KM03005HB2G	BLACK
					MODEL NO.	COLOR OF HOUSING
5	BREAK TERMINAL	1	C2680R-H C5191R-H, t=0.2△			MB:Ni ; Au PLATE
4	RING CONTACT	1	C5210-EH, t=0.25			MB:Ni ; Au PLATE
3	TIP SPRING	1	Ti-Cu, t=0.25			MB:Ni ; Au PLATE
2	EARTH CONTACT	1	C5210-EH, t=0.25			MB:Ni ; Au PLATE
1	HOUSING	1	PA9T+33%GF			BLACK
LTR	PART NAME	QTY	MATERIAL	REMARK		
DSND	TARRY	DATE	2003.03.13	3RD ANGLE PROJECTION	NAME	
DWN	TARRY	DATE	2003.03.13		φ2.5 MINIATURE JACK	
CHKD	JOHNSON	DATE	2003.03.13		CAT. No.	
APVD	KUNG	DATE	2003..03.13	UNIT: mm	KM03005H_2G	
KUNMING ELECTRONICS CO., LTD.					DWN.No.	
					A-03005H2G	004

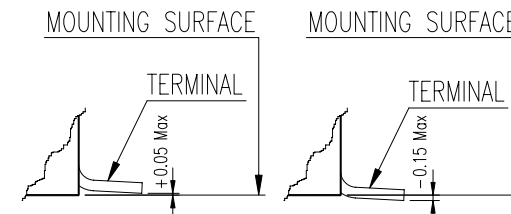
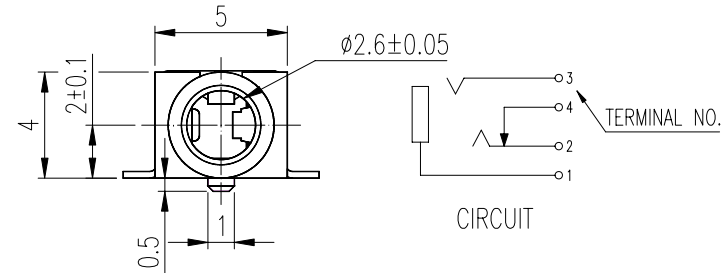
REVISIONS				
LTR	DESCRIPTION	DATE	REVISED	APPROVED
△x2	修改尺寸符合現品,修改 SMT 表示法及各五金平坦度要求.	2002.11.19	ROBIN	JOHNSON
△x1	增加穴號及 HT 標誌	2003.01.22	TARRY	JOHNSON
△x1	材質 C2680 變更材質為 C5191 防止變形	2003.03.13	TARRY	JOHNSON

△ All Pin terminals must keep Max 0.1 discrepancy
COPLANARITY TOLERANCE
